Report: TAB Report
Function: Test, Adjust, & Balance
Date: 11/26/2025
Completed By: National TAB

PROJECT
12-08-25 QT #1439 MESA, AZ

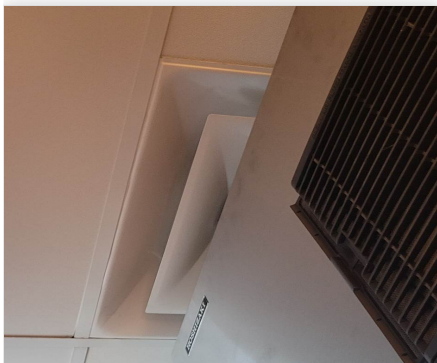
Issue Name : DAMPERS INACCESSIBLE
Description : RTU3 dampers should be accessible for TAB to done properly. Tiles cannot be move due to proximity of light canisters to steel beams and the hood. They are installed too far in to be reached on either side of row of lights. Recommend not installing tiles until kitchen has been balanced.
Created By : National TAB **Assigned To :** National TAB - Dan Hertenstein
Status : Open
Priority : High **Asset Tag :** RT-3
Originated Date : 12/10/2025 - Christine Weale - National TAB

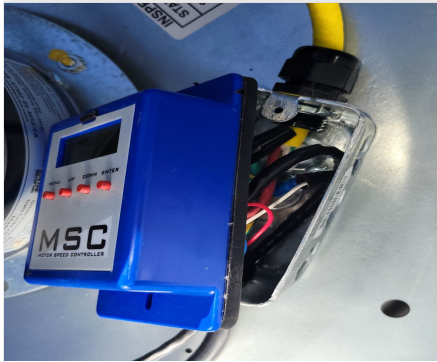
Issue Name : HINGE OR CUP INSTALLED ON WRONG SIDE
Description : Hinge should be opposite of grease cup. Fan cannot be tilted all the way back.
Created By : National TAB **Assigned To :** National TAB - Dan Hertenstein
Status : Open
Priority : Medium **Asset Tag :** EF3
Originated Date : 12/10/2025 - Christine Weale - National TAB

Asset: EF2

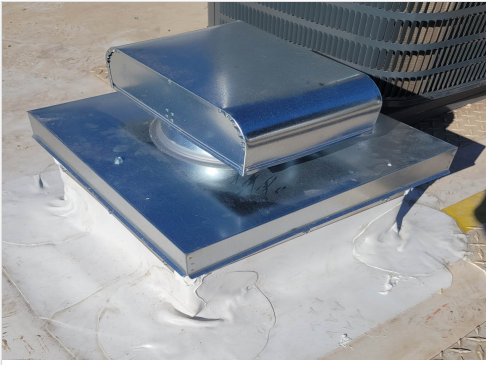
Notes:
EXHAUST FAN IN CEILING, INACCESSIBLE DUE TO COMBI-OVEN, REQUESTED INFO NOT GIVEN.
